CITY OF MILWAUKIE

PLANNING COMMISSION

5.1 HR-2024-002 - 1620 SE Waverly Dr (continuation)

Summary: Historic Resource Review (Type III)

Figure 3. Site plan showing location of proposed footprint expansion (highlighted). Expansion also includes the addition of two lanais (not highlighted but labeled).

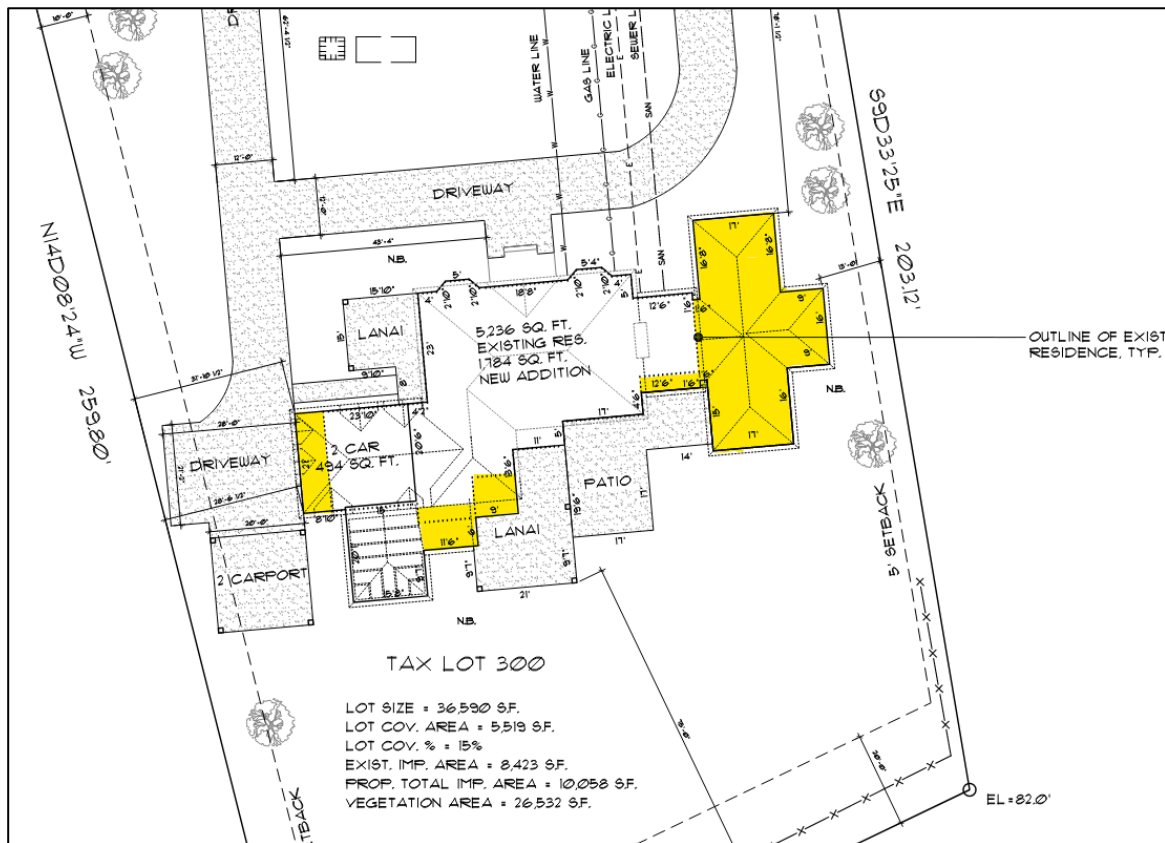
As noted, the applicant is proposing a significant east wing addition, the addition of a conservatory on the south elevation, and wall extensions on the south, west, and east elevations. The east wing addition was originally a concern for the city's consultant, not because it was inappropriate in scale, but because the placement obscured the view of the historic structure from the right-of-way. The most recent plans address this concern by shifting the addition slightly to the east. Staff believe this criterion is now met.

Figure 7. West elevation. Showing existing (left) and new garage entrance, lanai, window changes, and conservatory (right).

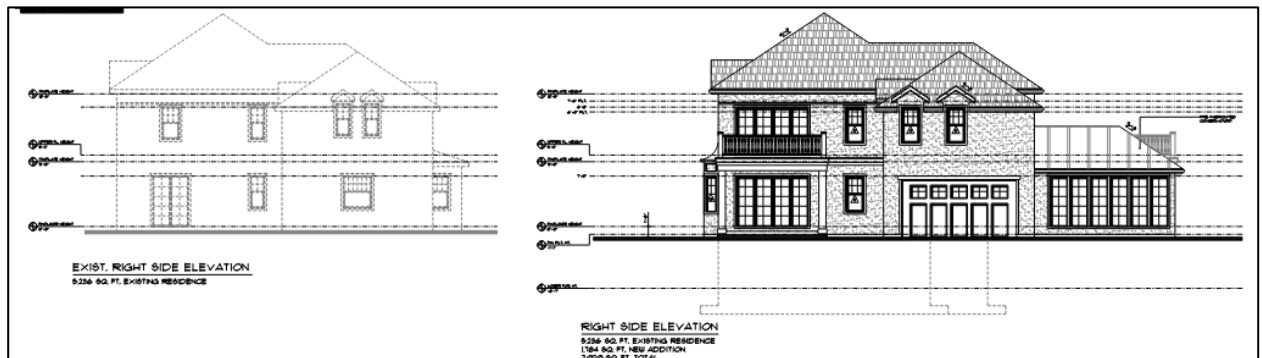
Earlier iterations of the plan involved increasing the roof height of the west wing which would modify the design of the pediments above the second story windows. The applicant is no longer proposing these modifications. Staff believe the criterion is met.
